REMARKS/ARGUMENTS

Amendments to the Drawings:

Title: STATOR DAMPER ANTI-ROTATION ASSEMBLY

Appl. No.: 10/002,594

FIG. 2

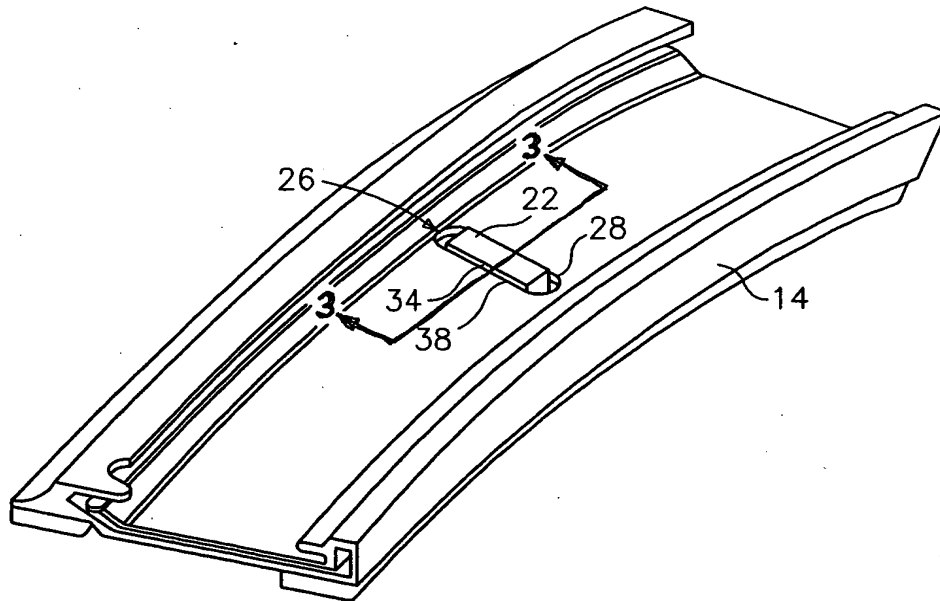
have been amended to designate the brazing material of claim 12 by a reference number and to show the plane 3 - 3.

Attached to the instant paper are replacement sheets of drawings which include changes to Figs. 2 and 3. The sheets, which include Figs. 1-4, replace the original sheets including Figs. 1-4. Figures 2 and 3 have been amended to designate the brazing material of claim 12 by a reference number and to show the plane 3 - 3.
